Access Compliance Report

Public Rights-of-Way

Intersection ID: 31895	Main Street: SLALOM_HILL_RD	Cross Street: STOWE_DERBY_DR	Location: SE
ADA ID: 18642F4842A1	Ramp Type: PerpDiag	Initial Pass/Fail: Fail	Overall Compliance: No
Severity Score: 33.75			
Codes/Mitigation Info/Possible Solution		Field Measurements/Component Compliance

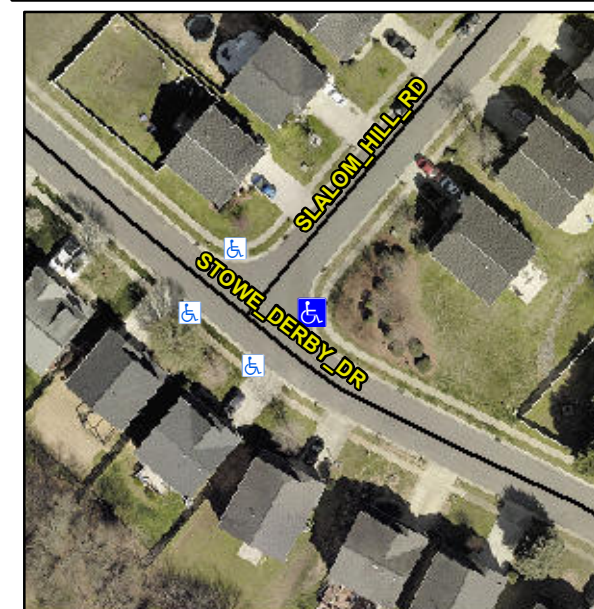
R304.5.1, R304.2.2, R304.5.3

Compliance	Description	Data	Compliance	Description	Data
N/A	Ramp Length (in)	48.0	No	Ramp Slope (%)	8.5
No	Ramp Width (in)	39.0	No	Ramp XSlope (%)	5.6
N/A	Flare Type LT	N/A	N/A	Flare Type RT	N/A
N/A	Flare Slope LT (%)	N/A	N/A	Flare Slope RT (%)	N/A
N/A	Flare Traversable LT?	N/A	N/A	Flare Traversable RT?	N/A
N/A	Landing Length (in)	N/A	N/A	DWS Provided?	N/A
N/A	Landing Width (in)	N/A	N/A	DWS Contrast?	N/A
N/A	Landing Slope (%)	N/A	N/A	DWS Length (in)	N/A
N/A	Landing X Slope (%)	N/A	N/A	DWS Full Width?	N/A
N/A	Landing Curb? (Y/N)	N/A	N/A	DWS Offset (in)	N/A
N/A	Shared Landing?	N/A			
N/A	Gutter Ponding?	N/A	N/A	Gutter Slope (%)	N/A
N/A	Gutter Lip Ht (in)	N/A	N/A	Gutter X Slope (%)	N/A
N/A	Painted X Walk1?	No	N/A	Painted X Walk2?	No
	X Walk 1 Direction	To NW		X Walk 2 Direction	To SW
N/A	X Walk 1 Width (in)	N/A	N/A	X Walk 2 Width (in)	N/A
	X Walk 1 Slope (%)	0.4		X Walk 2 Slope (%)	3.0
	X Walk 1 X Slope (%)	5.1		X Walk 2 X Slope (%)	1.7

N/A	Ramp inside XWalk1?	N/A	N/A	Ramp inside XWalk2?	N/A
	Road Slope (%)	4.1	N/A	Clear Space?	N/A
	Road X Slope (%)	2.4	N/A	Clear Space to XWalk (in)	N/A
N/A	Any Obstructions?	N/A	N/A	Storm Grate/Utility Hazard?	N/A
	Obstruction Type			Storm Grate/Utility Type	
		N/A			N/A
			Yes	Surface Condition? (G/P)	Good

Remove & Replace Curb Ramp With Two New Directional Ramps or Equivalent.
